Beall's Manor: Preliminary Plan No.120140030

Staff Report Date: 7/03/14

Request to subdivide Parcel 823, Tax Map JR563 to create three (3) lots, located at the terminus of Spearmint Lane, approximately 150 feet southeast of the intersection with Amberleigh Terrace; 2.0 acres; R-200 Zone; Cloverly Master Plan and Cloverly Policy Area.

RE: Preliminary Plan No. 120140030
Beall's Manor

Figure 3. Protected Tree Removals and Impacts

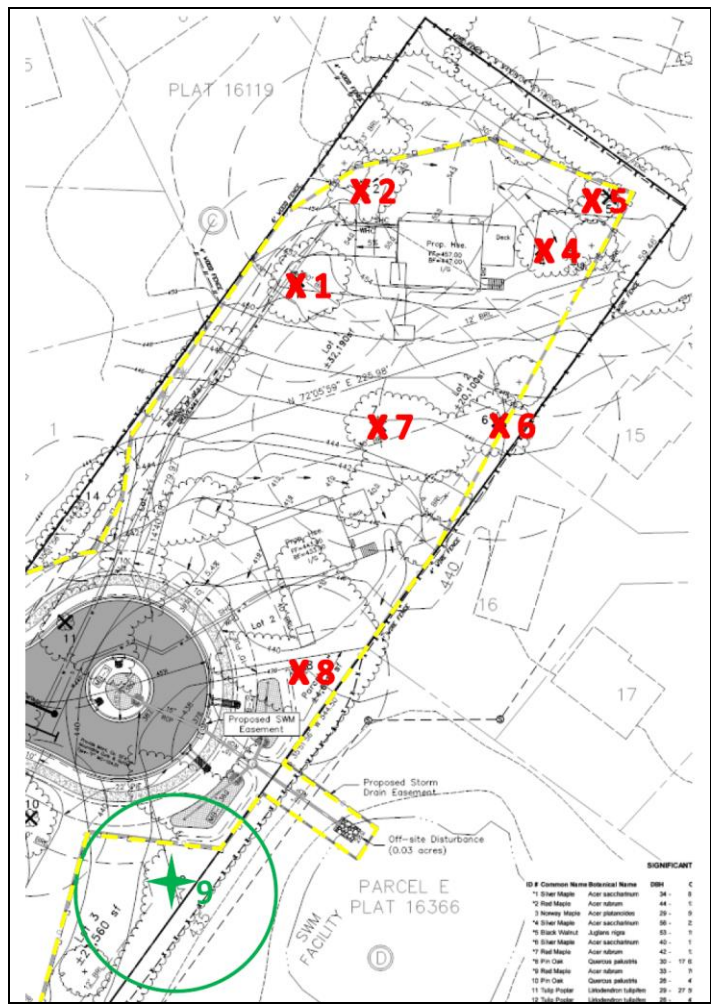
Variance Request - The Applicant submitted a variance request dated January 31, 2014 for the removal of seven (7) Protected Trees and impact to one (1) Protected Tree (Attachment F). All of these Protected Trees are rated in poor or fair condition.

Mitigation - Staff recommends that mitigation for the loss of the Protected Trees be provided onsite. Mitigation should be at a rate that approximates the form and function of the tree removed. The mitigation is based on Staff's practice at the time the variance request was received whereby mitigation was not required for trees in poor condition. Staff recommends that replacement occur at a ratio of approximately 1-inch caliper for every 4-inch DBH removed. Mitigation for the removal of the three Protected Trees in fair condition (Trees #1, 7, and 8) must be provided in the form of nine (9) native canopy trees with a minimum size of three inches in diameter at breast height. While these trees will not be as large as the trees lost, they will provide some immediate canopy and will help augment the functions lost.

Variance Recommendation - Staff recommends that the variance be granted and mitigation required.

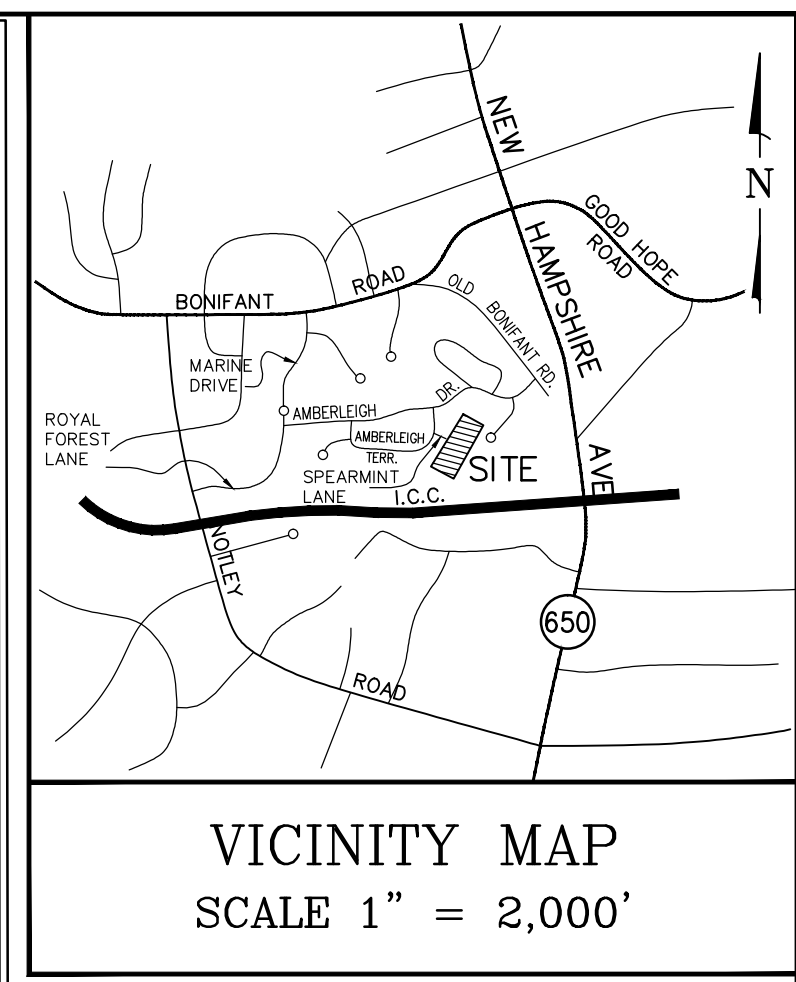
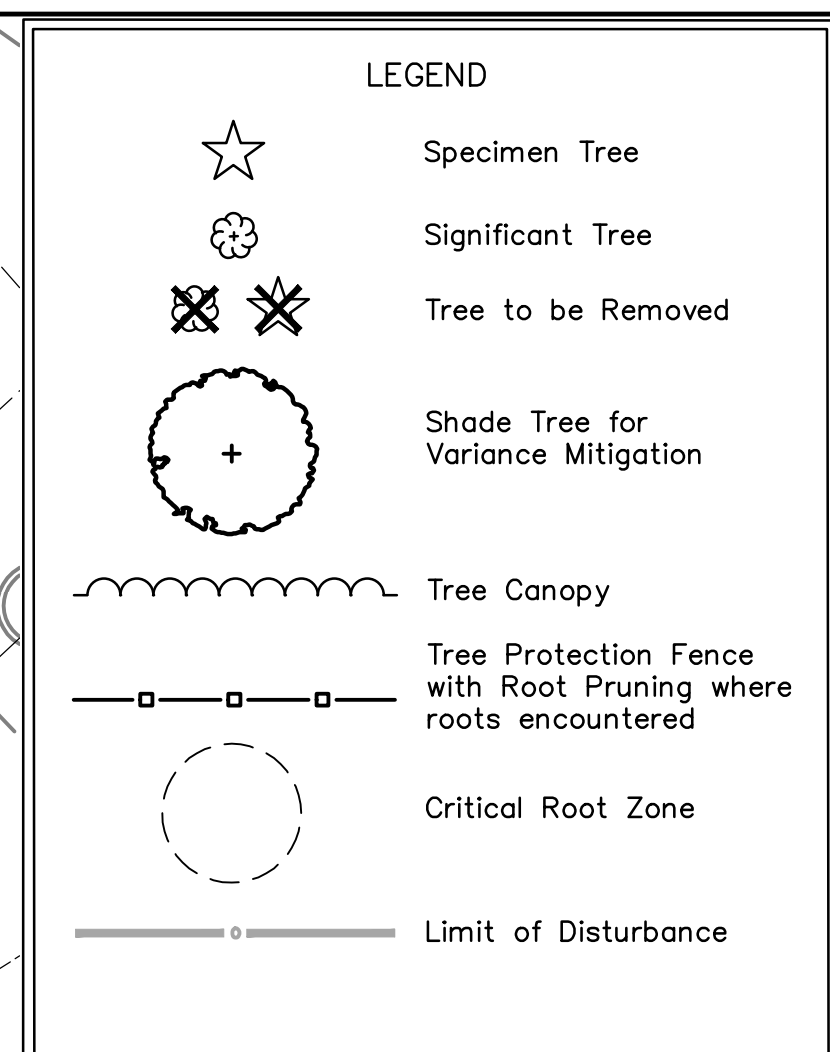
1. Show necessary dedication of 27'-4" per standard MC-210.03 (Modified Tertiary Residential Street).
2. Public Improvements Easements will be required along all Modified Tertiary classification roadways. The Declaration of Public Improvements Easement document is to be recorded in the Land Records of Montgomery County. The deed reference is to be provided on the record plat. Unless otherwise noted, the Public Improvements Easement is to be a minimum width of ten (10) feet with the overlapping Public Utilities Easement being no less than twenty (20) feet wide.

3. Grant a 15' PIE for a connector trail towards New Hampshire Avenue. The placement of this easement to be determined prior to certified preliminary plan. Coordinate with Ms. Patricia Shepherd of the Division of Transportation Engineering at (240) 777-7231.

4. Grant necessary slope and drainage easements. Slope easements are to be determined by study or set at the building restriction line. Size storm drain easement(s) prior to record plat. No fences will be allowed within the storm drain easement(s) without a revocable permit from the Department of Permitting Services and a recorded Maintenance and Liability Agreement.

5. Given that MD 200 is a State-maintained roadway, we defer to the Maryland State Highway Administration regarding the capacity analysis for the downstream storm drain system. The runoff from the site is tributary to an existing adjacent stormwater management facility, which ultimately conveys under the Intercounty Connector (MD 200) via a 72" RCP culvert.

6. Prior to certification of the preliminary plan, design the storm drains at the end of the cul-de-sac on Spearmint Lane to not discharge within the PUE. Also, revise the downstream drainage analysis plan to address inconsistencies in the placement of the storm drains (in relation to the preliminary plan) and the erroneous labeling of the drainage areas and stormwater management facilities.

7. This site is located in the Northwest Branch (Class IV) watershed. In accordance with Section 49-33(l) of the Montgomery County Code, curb and gutter may not be installed in an environmentally sensitive watershed unless certain waiver criteria have been satisfied.

8. Based on a review of the information submitted to date, a waiver to allow curb and gutter has not been granted for this site. As a result, open section roadways will be required within this subdivision. (The Department of Permitting Services may lift this requirement if the applicant is able to provide documentation which satisfactorily demonstrates the use of curb and gutter will not significantly degrade water quality. This documentation is to be submitted in triplicate to Mr. Atiq Panjshiri of MCDPS, for subsequent review and comment by this Department and the Maryland-National Capital Park & Planning Commission (Environmental Planning Division.)

PRELIMINARY FOREST CONSERVATION PLAN
BEALLS MANOR
BEALLS MANOR
PARCEL 823 L. 30510 F. 191
5TH ELECTION DISTRICT - MONTGOMERY COUNTY - MARYLAND

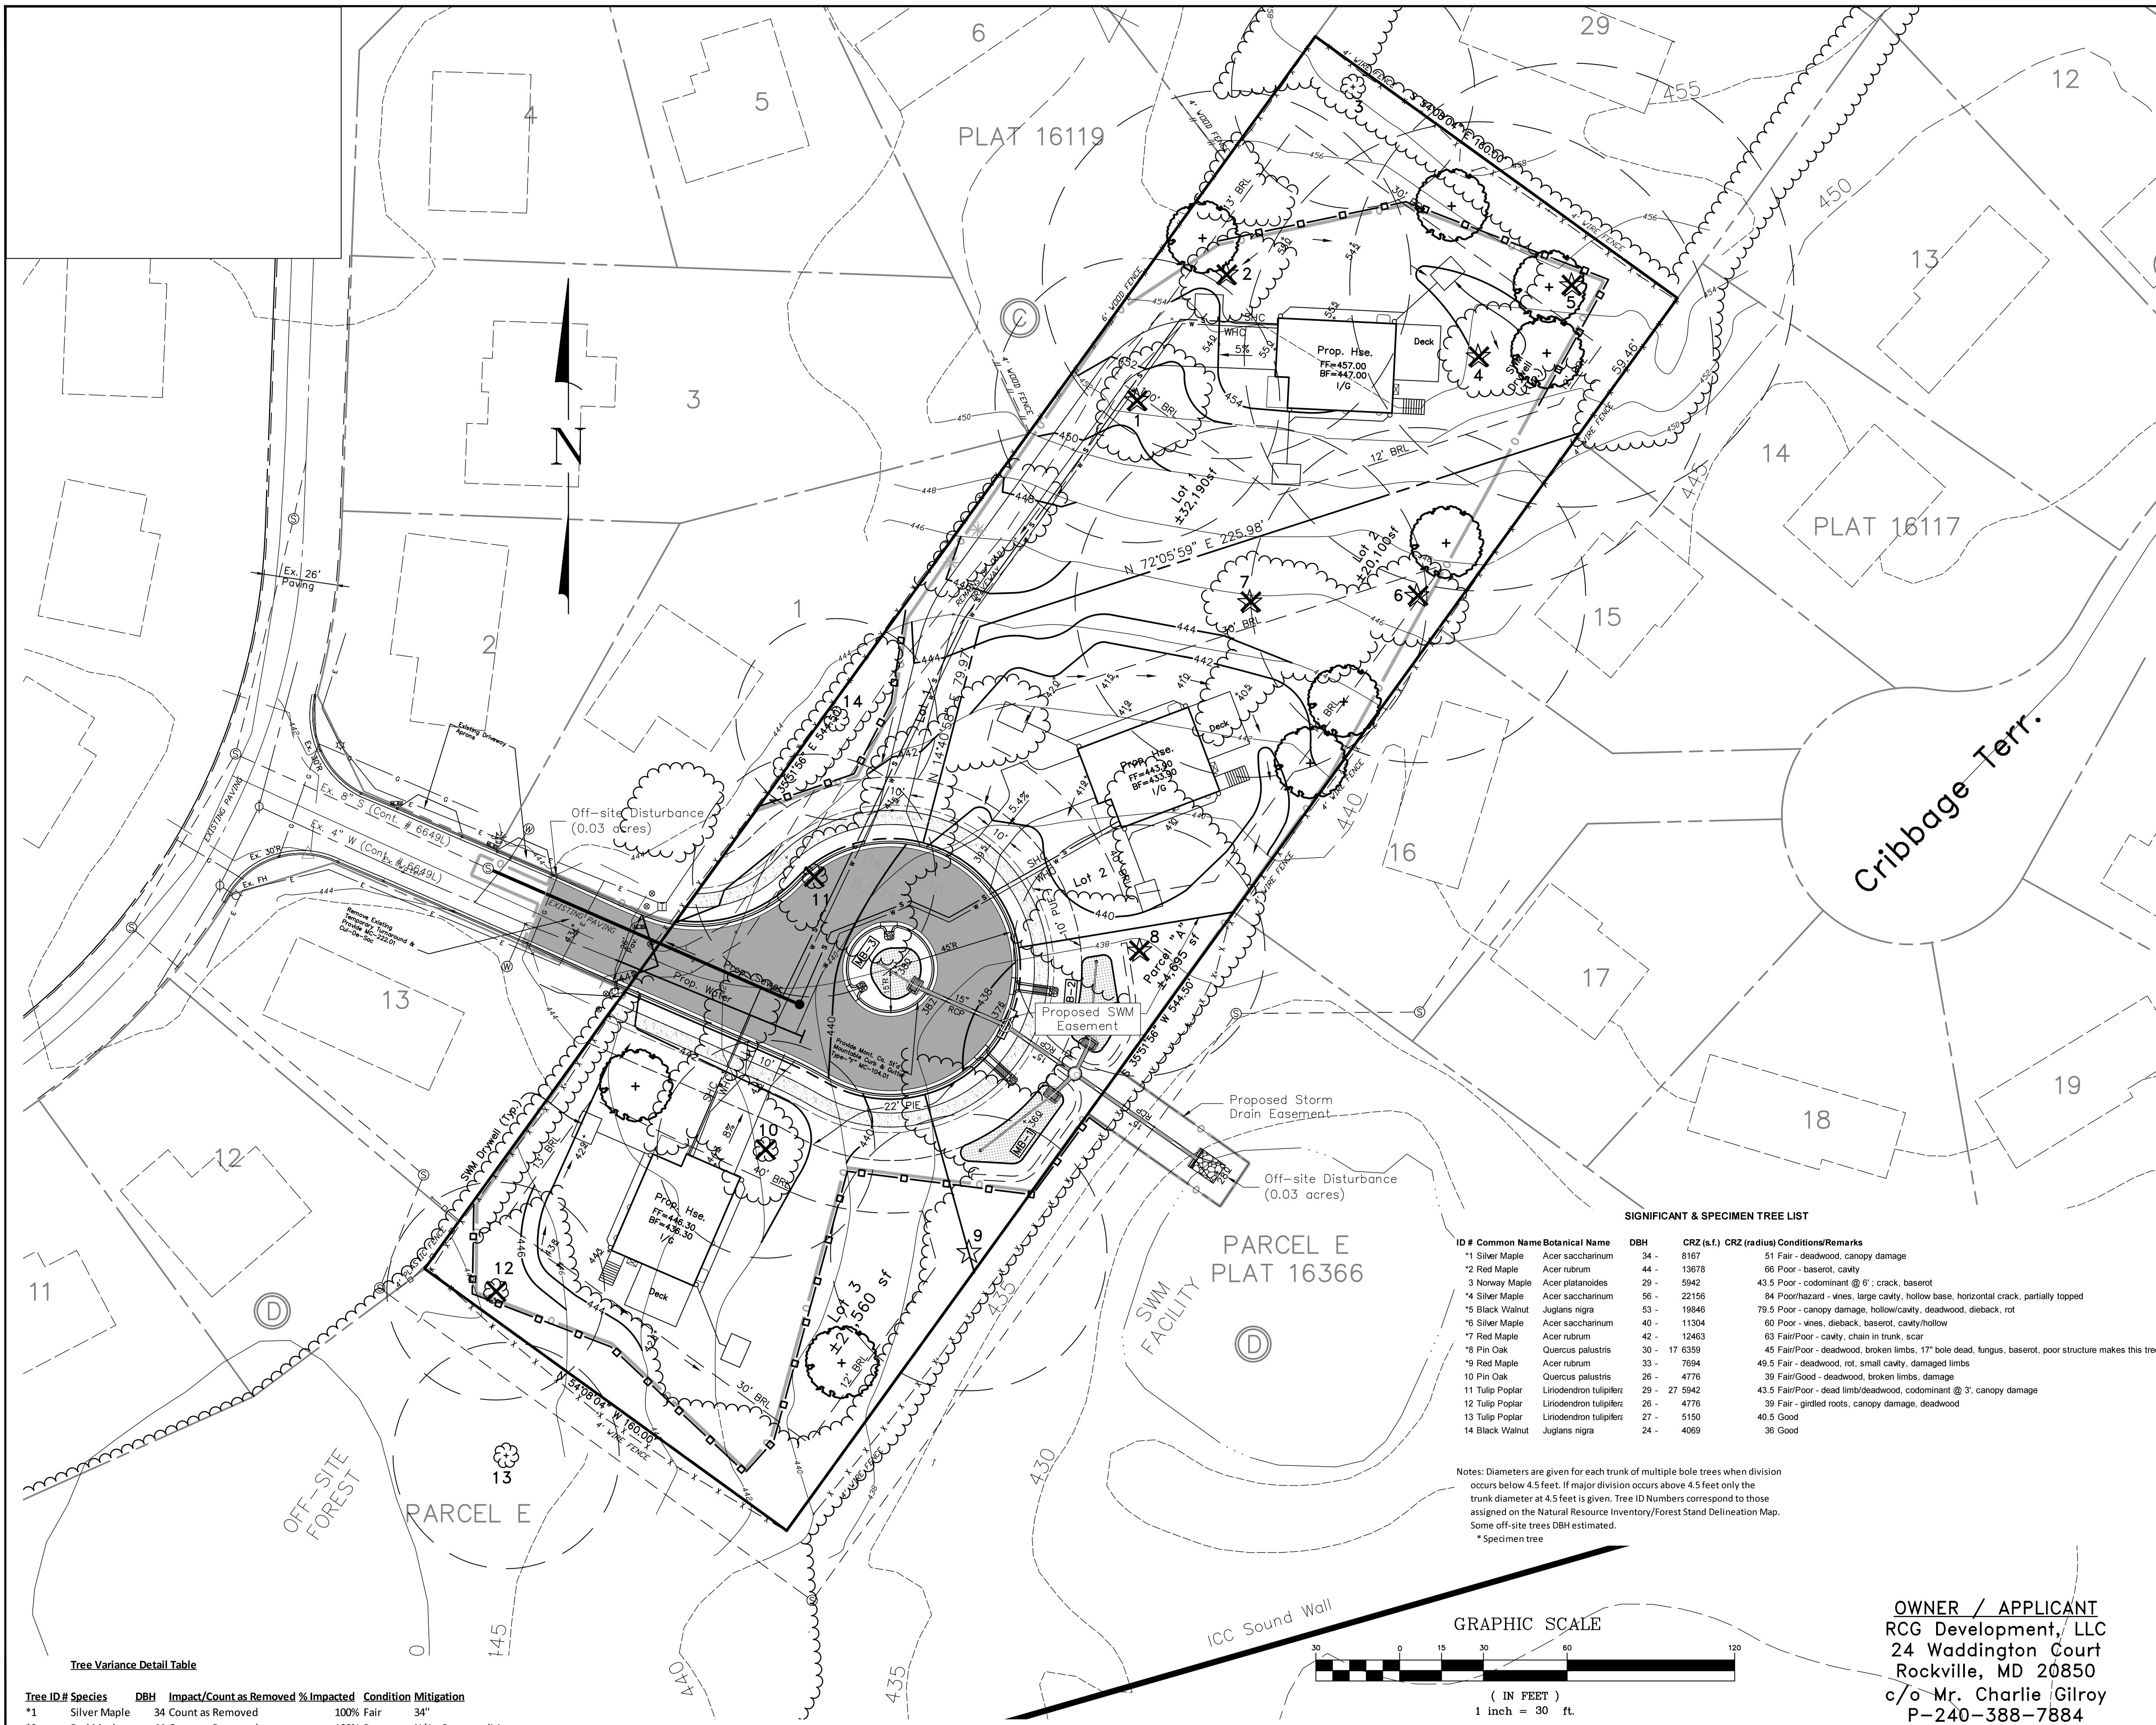
Tree ID #	Species	DBH	Impact/Count as Removed	% Impacted	Condition	Mitigation
*1	Silver Maple	34	Count as Removed	100%	Fair	34"
*2	Red Maple	44	Count as Removed	100%	Poor	N/A - Poor condition
*4	Silver Maple	56	Count as Removed	100%	Poor	N/A - Poor condition
*5	Black Walnut	53	Count as Removed	100%	Poor	N/A - Poor condition
*6	Silver Maple	40	Count as Removed	100%	Poor	N/A - Poor condition
*7	Red Maple	42	Count as Removed	100%	Fair/Poor	42"
*8	Pin Oak	30	Count as Removed	100%	Fair	30"
*9	Red Maple	33	Impact Only	17%	Fair	Stress Reduction Measures

Total: 106"
106"/4 - 26.5" to be replanted with 3" trees = 9 trees
